December 10, 2020  
**GS# 210-070 New Bookstore**  
**Mississippi Delta Community College**  
**Moorhead, Mississippi**

## Addendum No. 2

SHEET  
**A121R**  
SZZARCH# 2018  
DRAWN BY: rep / sz  
CHECKED BY: SZ  
DATE: 12/10/20

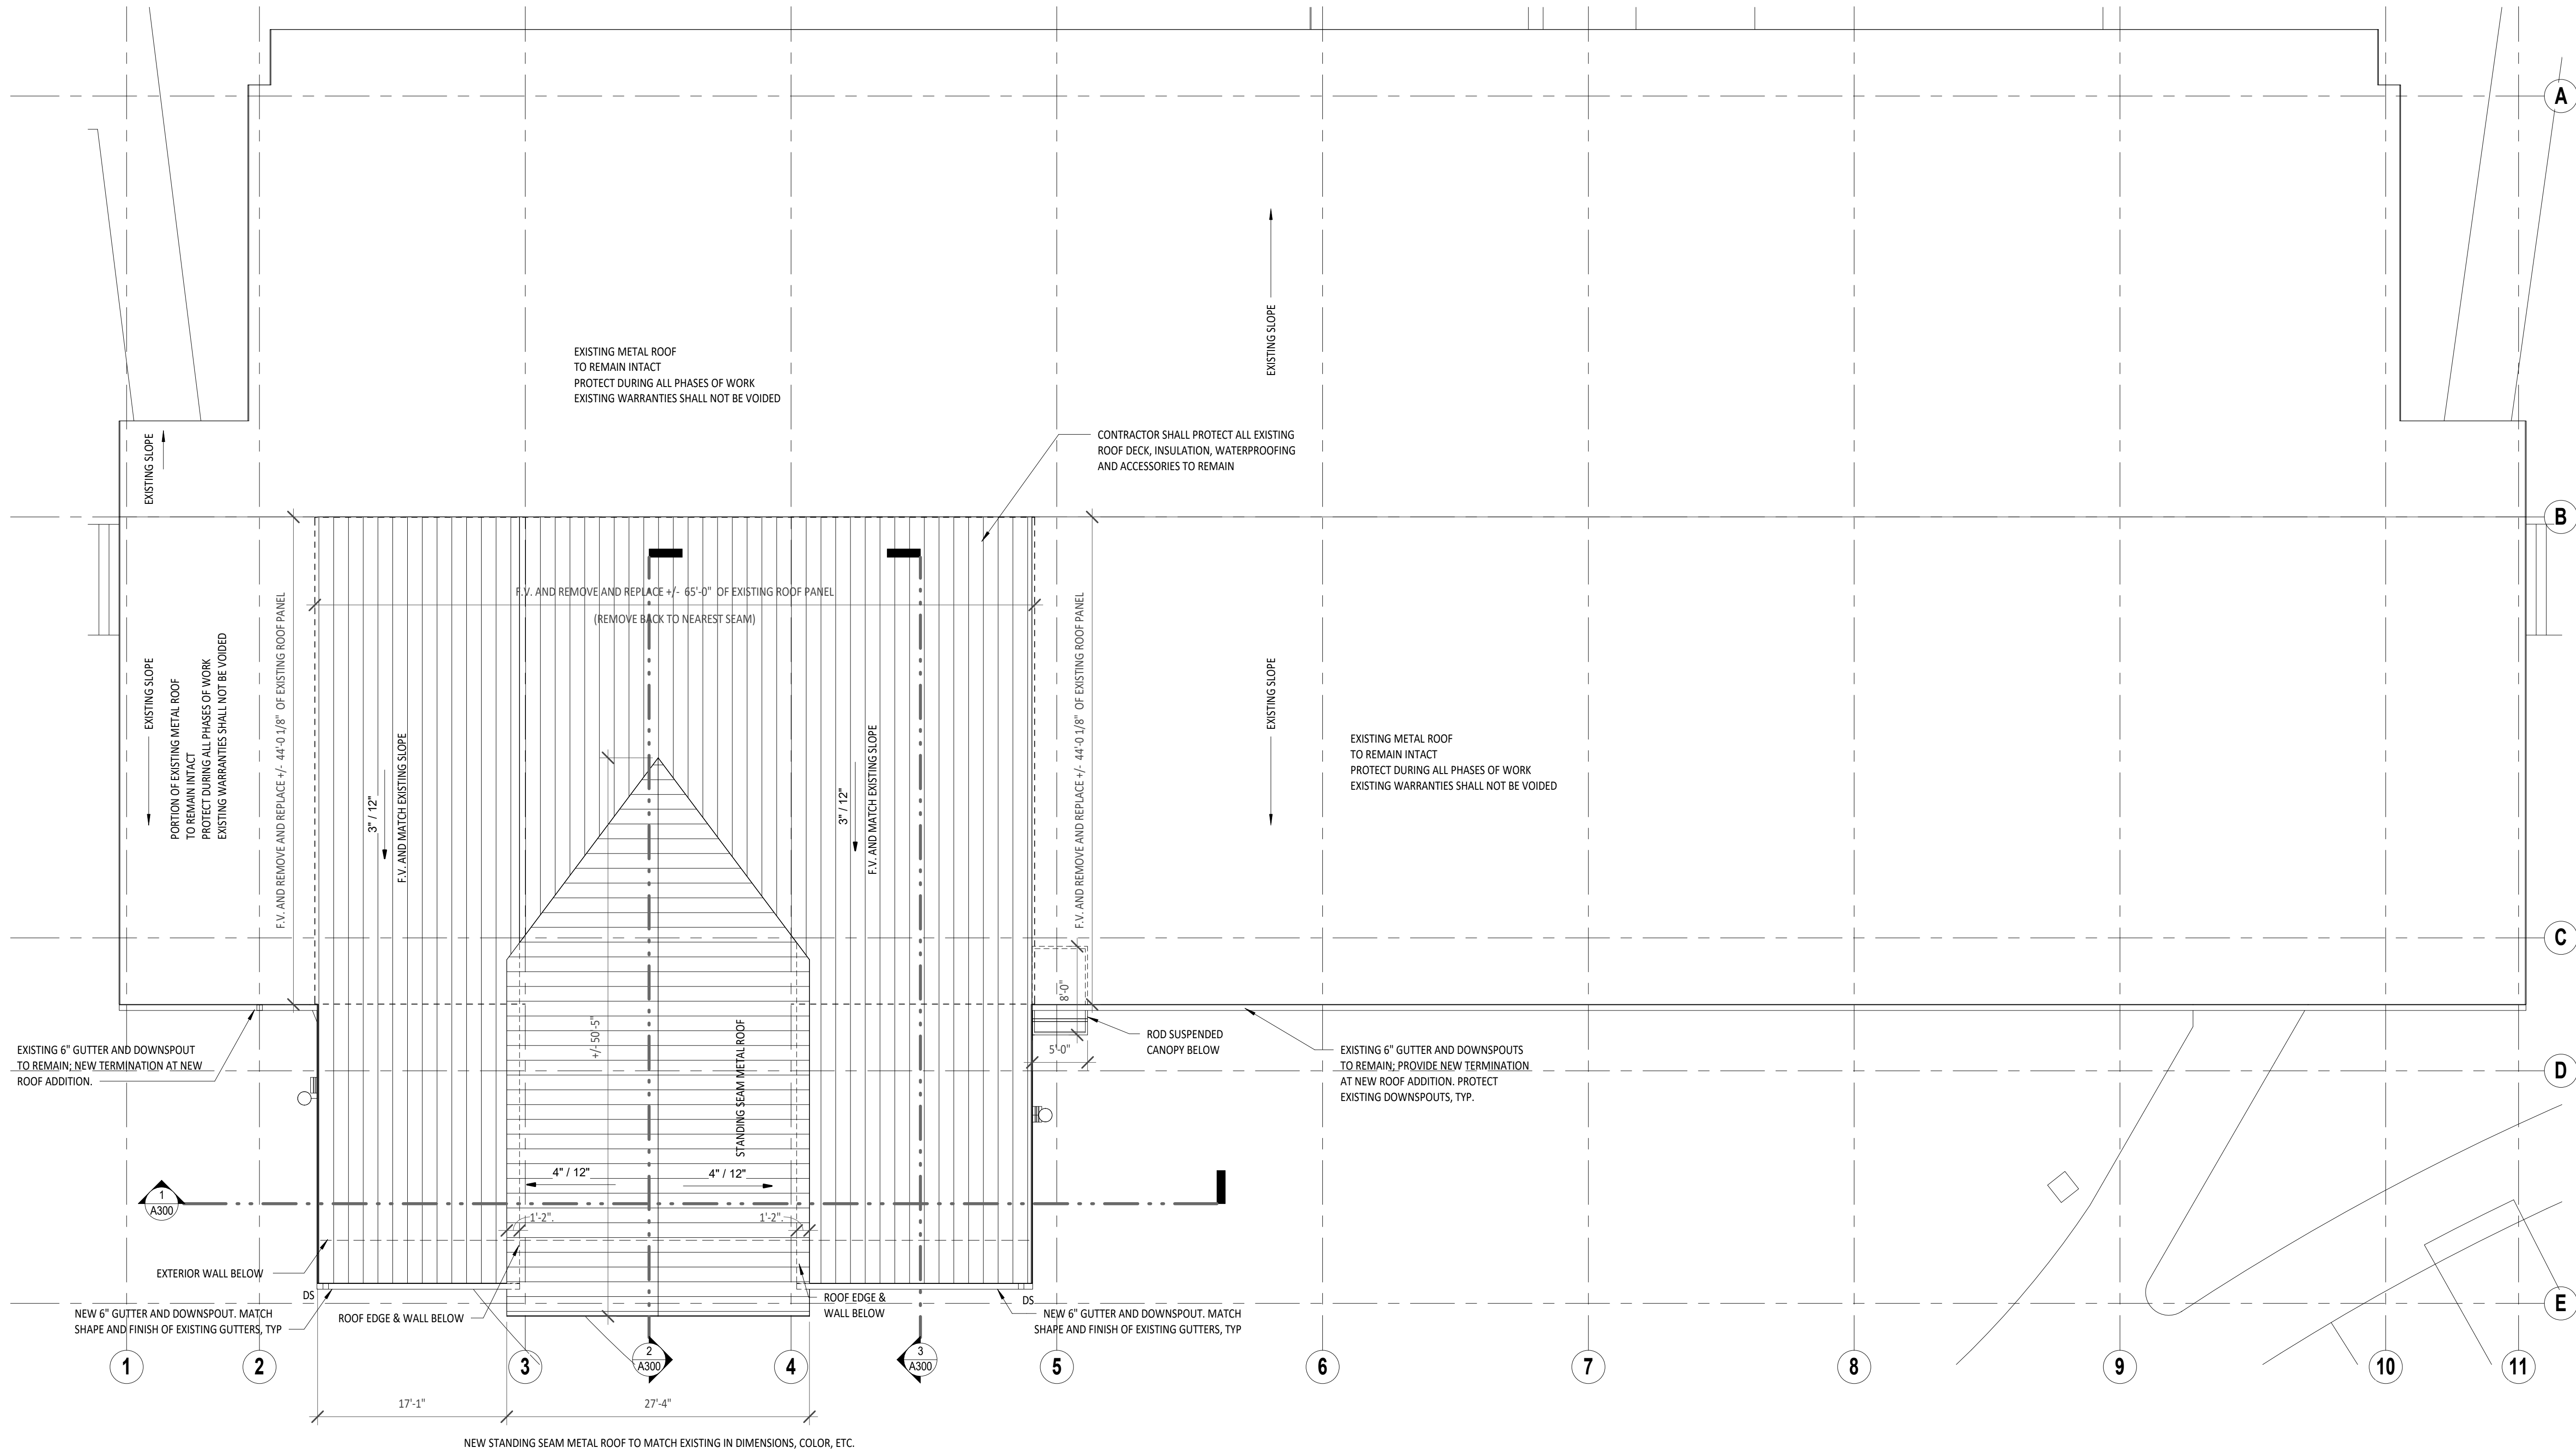
- a. Sheets A121 and A200: Modify existing gutter and downspouts, and provide new gutters and downspouts with splashblocks to match existing – see attached revised sheets.
- b. Sheet A611 Finish Key, ADD Glass Laminate –  $\frac{3}{4}$ " Crystal Polymer panel with matching edgebanding
- c. Sheets P100, MD100, M100, M200, FPD100, FP100 – added sheet title and scale, see attached revised sheets.
- d. Sheet E002: Added main device type and A.I.C. rating –see attached revised sheet.
- e. Sheet E101, E201: added sheet title and scale, see attached revised sheets.
- f. Sheet E301: Added sheet title and scale. Added General Notes D and E. Modified floor plan Keynote 1. Added floor plan Keynotes 4 and 5. Added CATV outlet at gift wrap counter. See attached revised sheet.
